PLANNING DEPARTMENT – Development Review Services

**RE: Albuquerque Biopark Zoo Penguin Exhibit (File: K13D034G)**  
**Grading & Drainage Plan, Engineer's Stamp Date 9-15-2016**  
**Supplemental Information, Engineer's Stamp Date 10-5-2016**

RE: **ALBUQUERQUE BIOPARK ZOO PENGUIN EXHIBIT**  
**RESPONSE TO REVIEW COMMENTS DATED September 30, 2016**

SHEET TITLE  
BUILDING SECTIONS

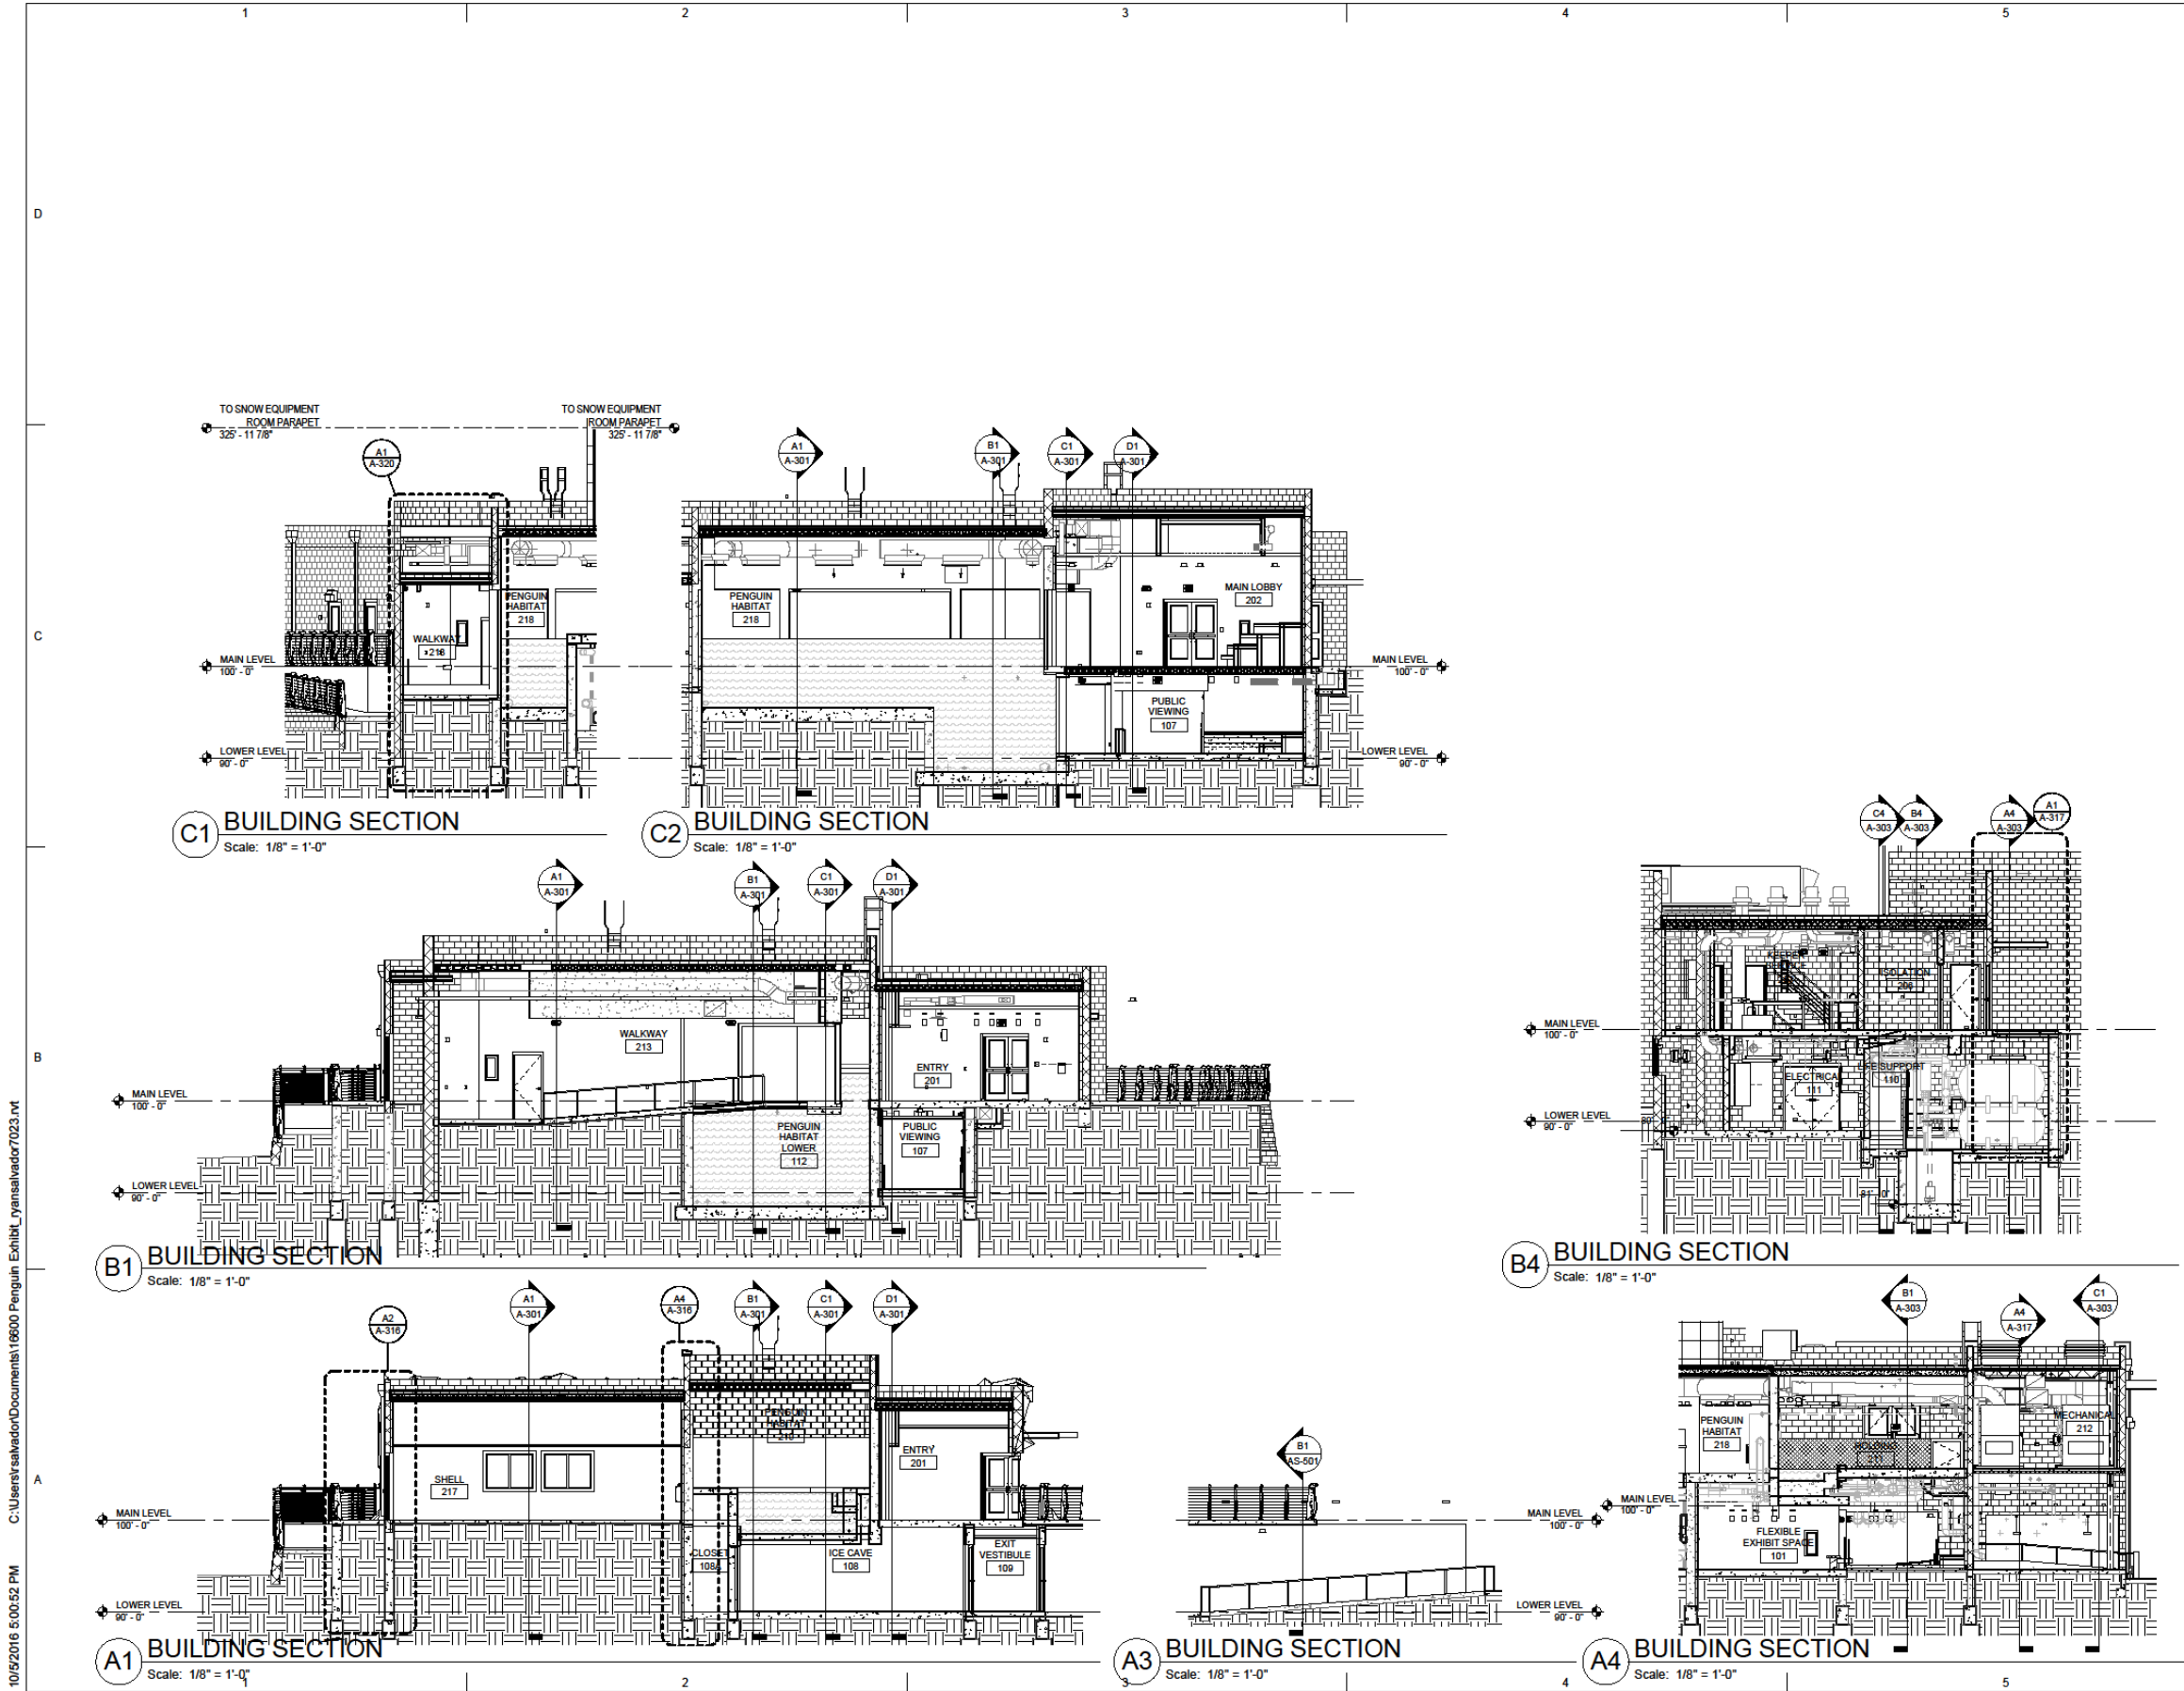
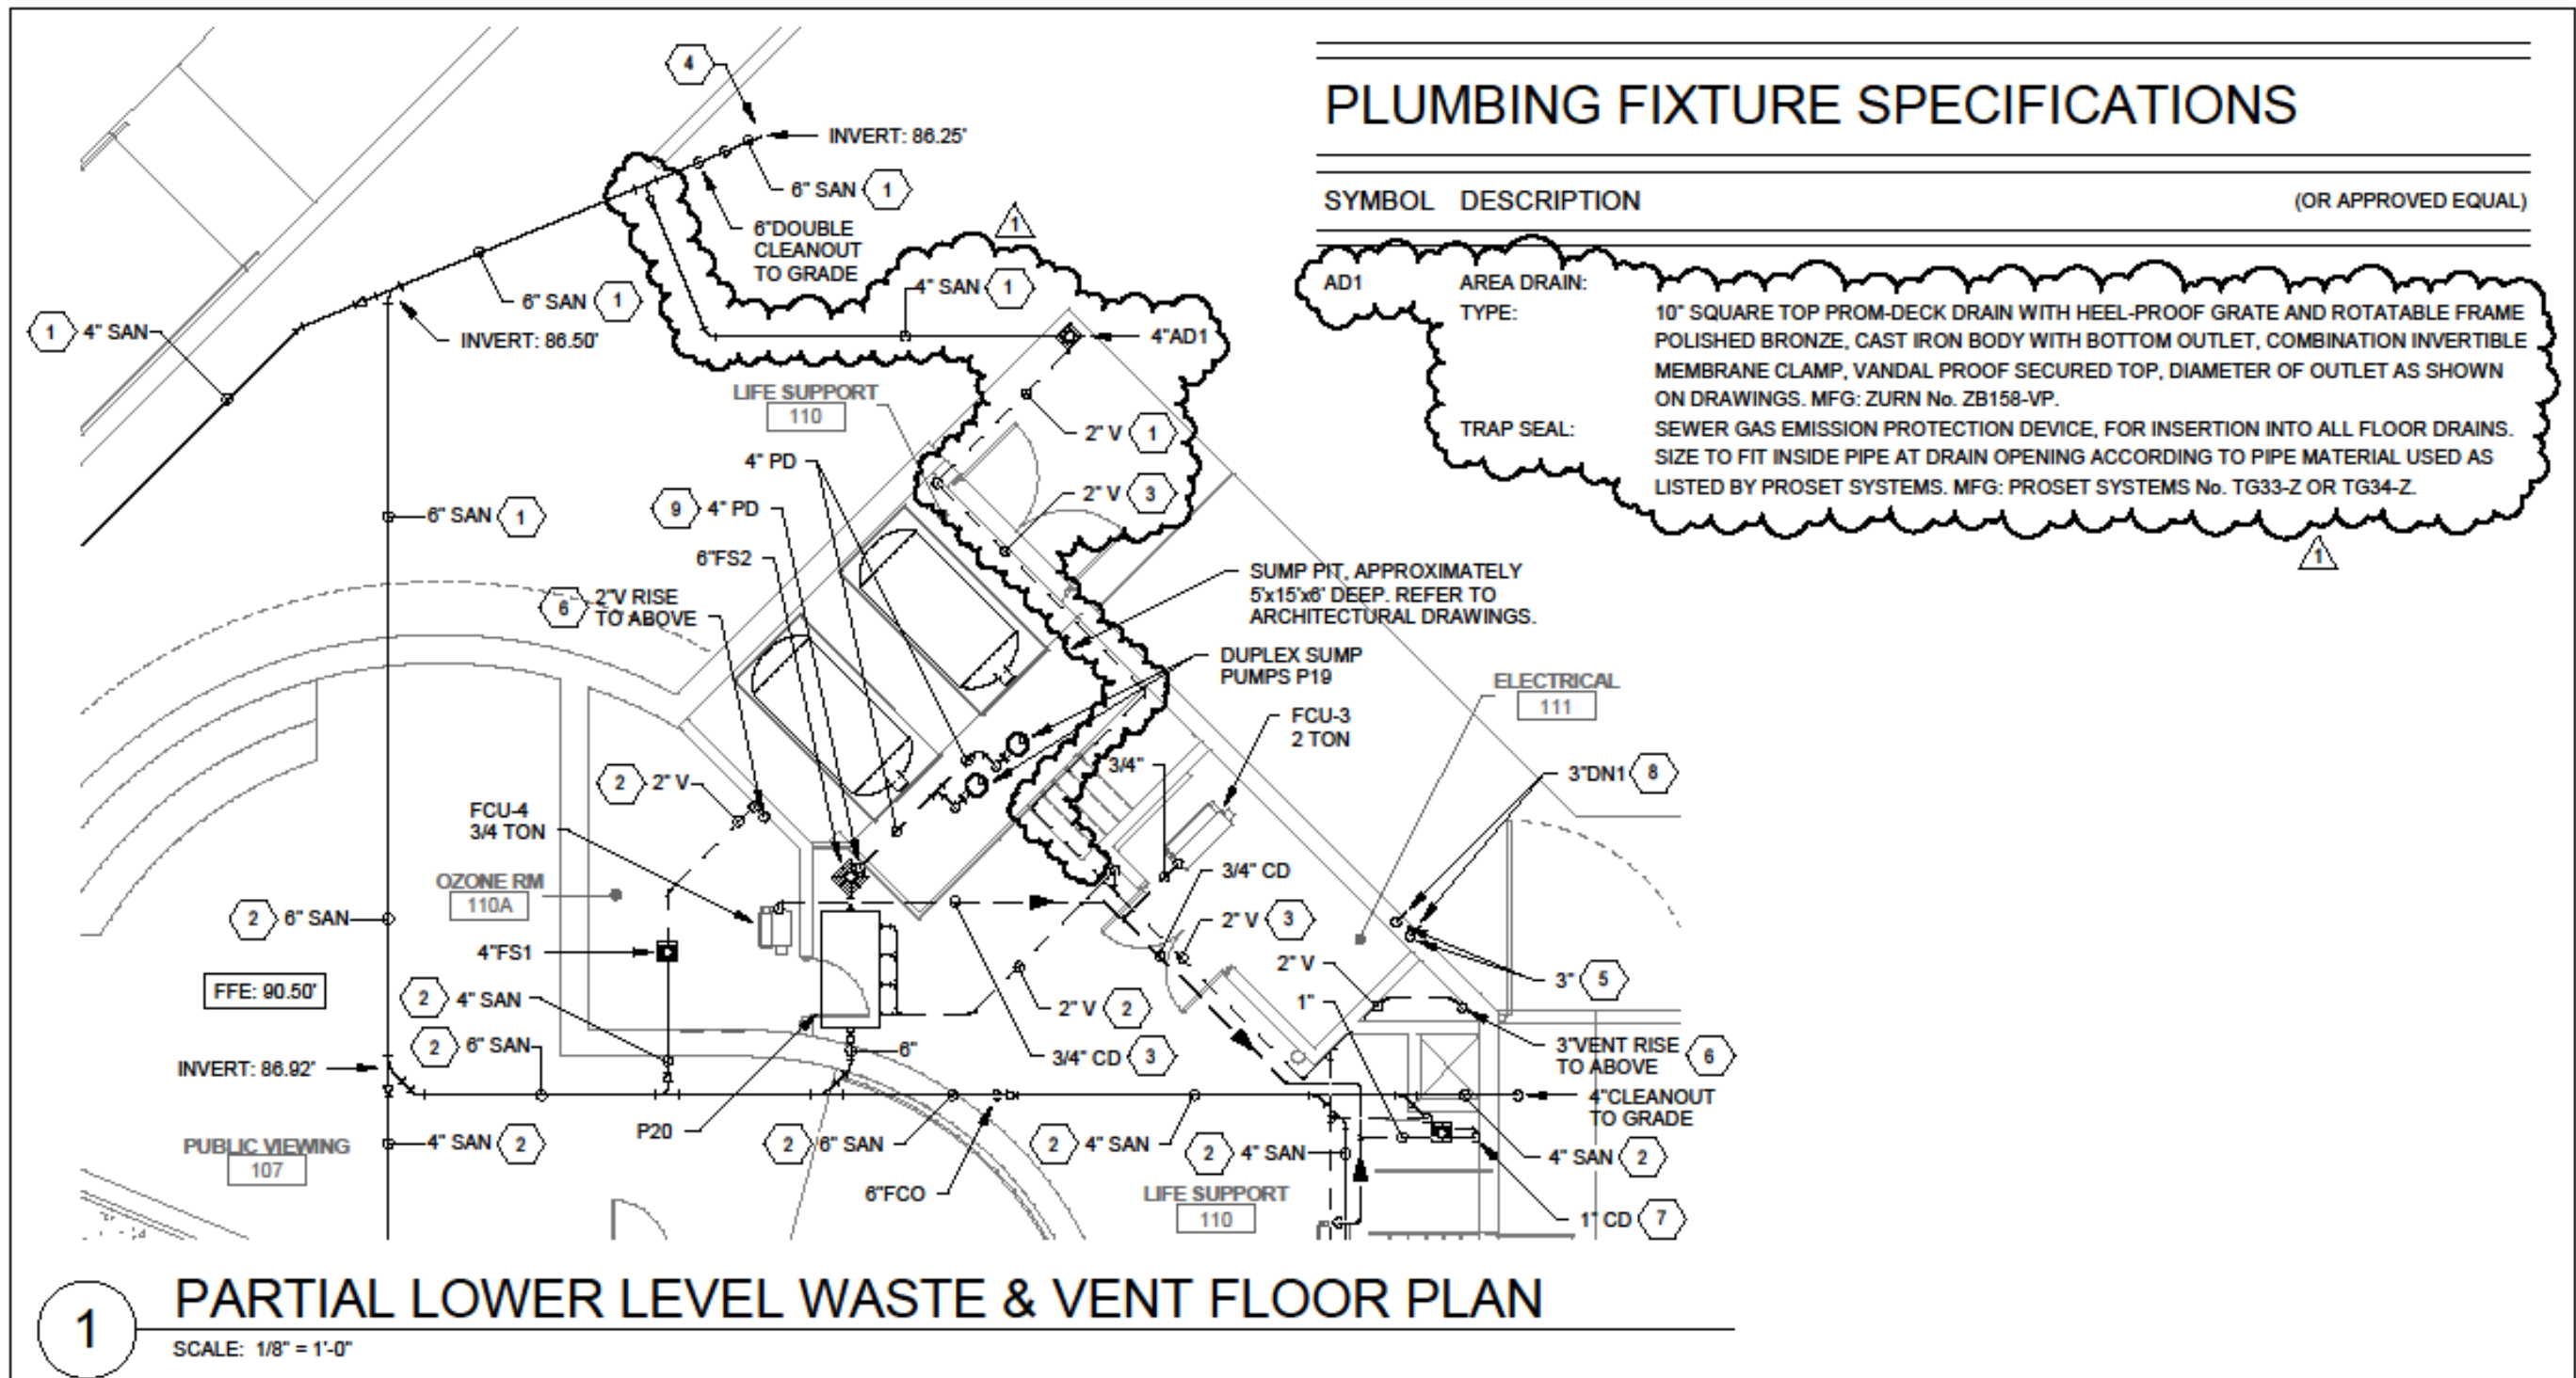
7. The architectural sections showing how the building relates to the site are included. The sections include the open mechanical area on the east side.

**LOWER LEVEL WASTE & VENT FLOOR PLAN**

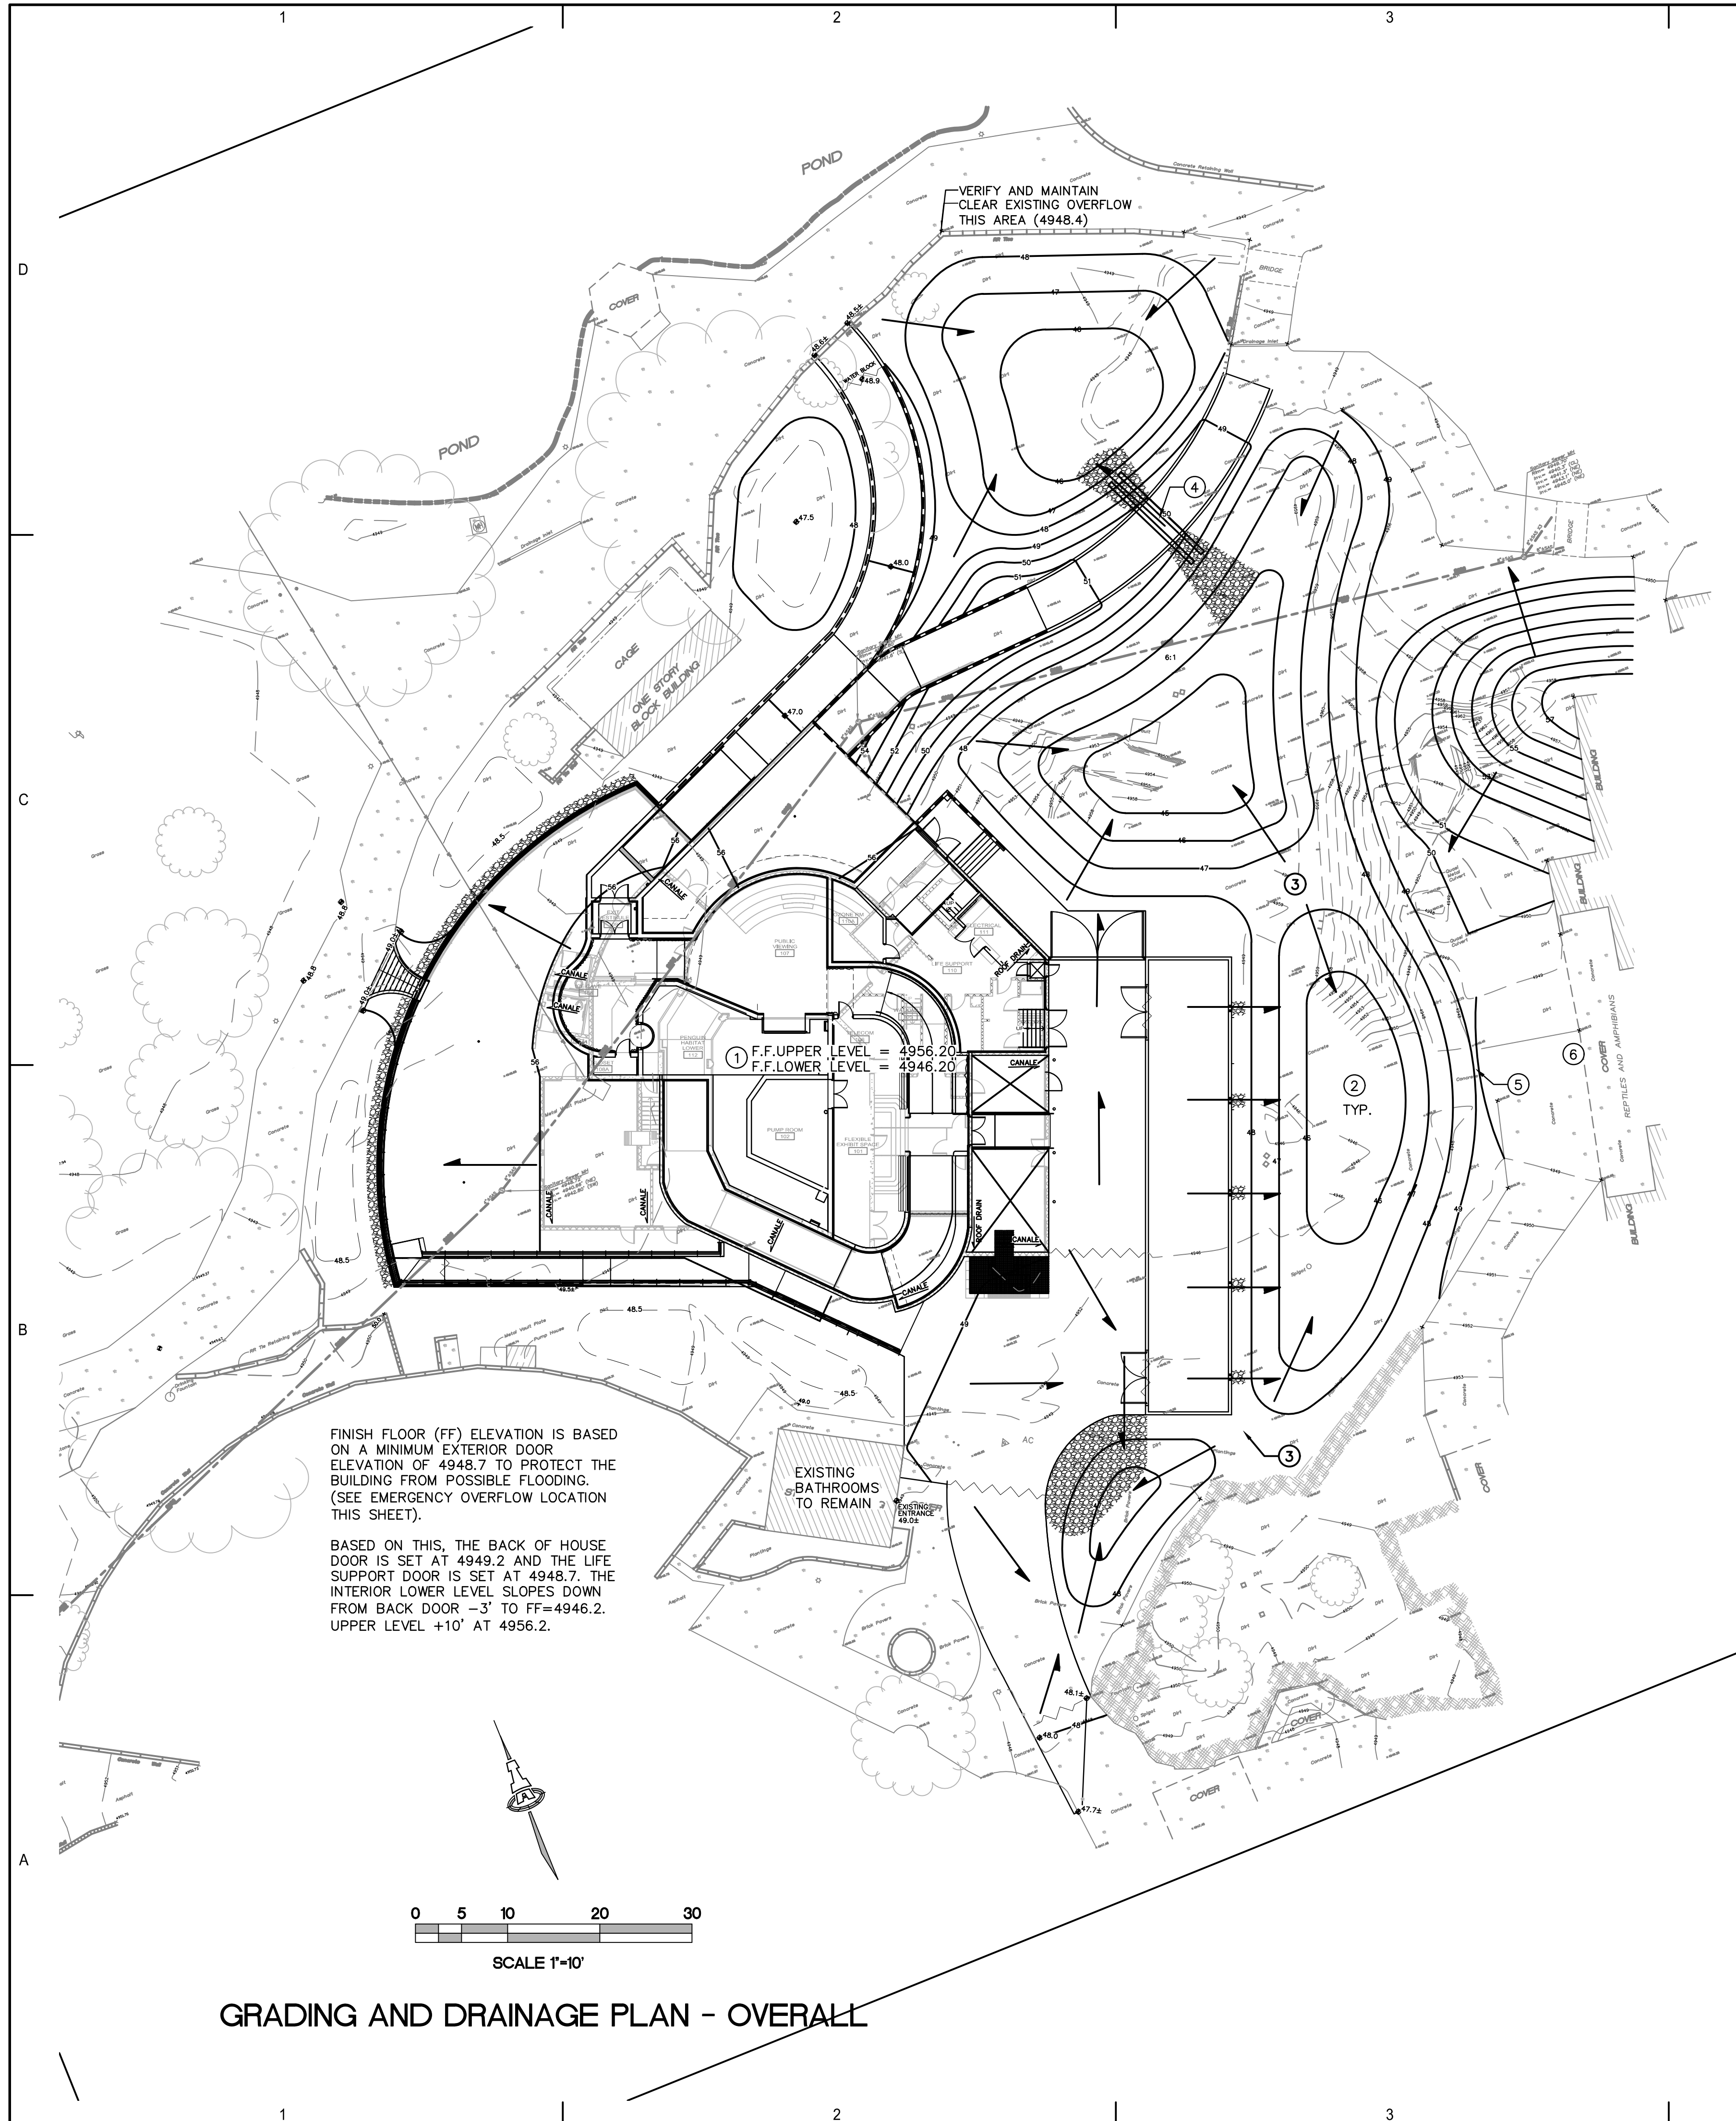
5. A basin exhibit for the project is included.
6. The plumbing plan will be provided as soon as I receive it. This plan calls out the ramp trench drain connection to the SAS system and is currently under review as part of the electronic submittal. In addition, the small floor drain in the concrete landing on the north side (at the bottom of the stairs) will also tie to the SAS system. The reason for this is that the door / landing in this area is below grade and must be sealed to prevent groundwater from rising up into the space. Therefore, the only drain options are sump pump (200 sf with 100-year  $Q=0.02$  cfs) or tie to SAS.
